Rockport LE- ADA Evaluation

Report Date: 01/15/2024

LE-Rockport TX, ADA Evaluation

Accessibility Evaluation

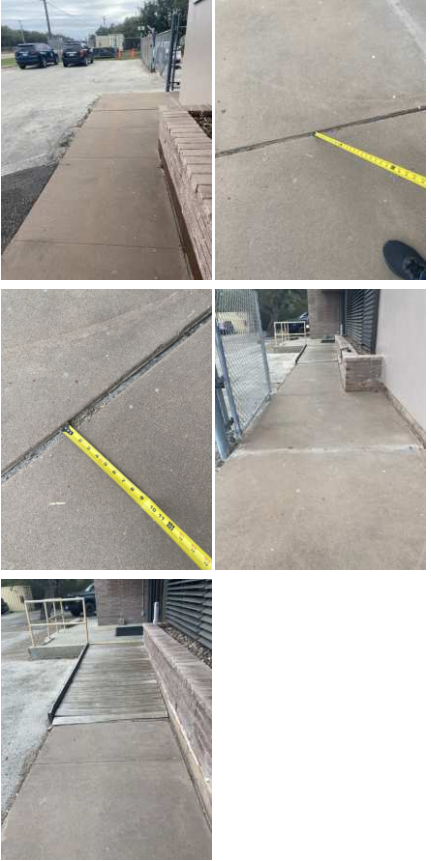
Finding Number	Area Description	Finding	As Built	Recommendation	Citation	Photos	Figure
4	Exterior of Property (Public): Parking Lot (0 Spaces) - Accessible Van Stall Requirments	The van stall is missing a sign identifying it as a van accessible stall. Parking space identification signs shall include the International Symbol of Accessibility. Signs identifying van parking spaces shall contain the designation "van accessible."	N/A	https://www.access-board.gov/ada/#ada-502_6	2012 TAS Section: 502.6 2010 ADAS Section: 502.6		
5	Exterior of Property (Public): Parking Lot (0 Spaces) - Access Aisle Requirments (Van)	The access aisle is in not nearly compliant. The access ai the minimum width. The access aisle is not as long as the parking space it serves. There are no markings to discourage parking. The floor or ground surface is not firm stable or slip resistant. The parking space contains changes in level and/or gaps that exceed the maximum allowable requirements.	Access aisle width requirments depend on van stall size. van stall 11' access aisle 5' or van stall 8' access aisle 8'	N/A - Refer to Finding	2012 TAS Section: 502.3 2010 ADAS Section: 502.3

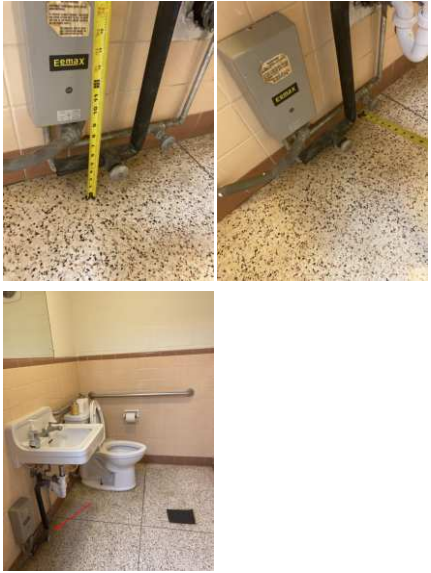
23	First Floor Main Building LOBBY (Public): Lobby Area - Restroom (Unisex)	The water and drain pipes under the lavatory are not adequately insulated. Water supply and drain pipes under lavatories and sinks shall be insulated or otherwise configured to protect against contact. There shall be no sharp or abrasive surfaces under lavatories and sinks.	N/A	https://www.access-board.gov/ada/#ada-606_5	2012 TAS Section: 606.5 2010 ADAS Section: 606.5

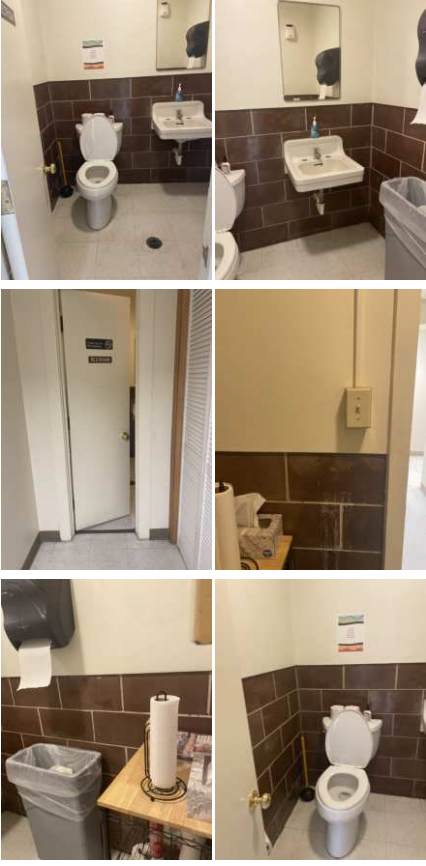
35	First Floor Main Building LOBBY (Public): Lobby Area - Restroom (Unisex) - PRIVATE/STAFF ONLY	Accessible toilets must have grab bars installed. The side grab bar must extend at least 54 inches minimum beyond the rear wall and start a maximum of 12 inches from the rear wall. The rear grab bar must be a minimum of 36 inches long and extend from the centerline of the toilet 12 inches minimum on one side and 24 inches minimum on the other side. Grab bars shall be installed in a horizontal position, 33 inches minimum and 36 inches maximum above the finish floor measured to the top of the gripping surface.	There are no grab bars installed at this time.	https://www.access-board.gov/ada/#ada-604_5 Review grab bar componets to make accessible https://www.access-board.gov/ada/#ada-609	2012 TAS Section: 604.5 2010 ADAS Section: 604.5
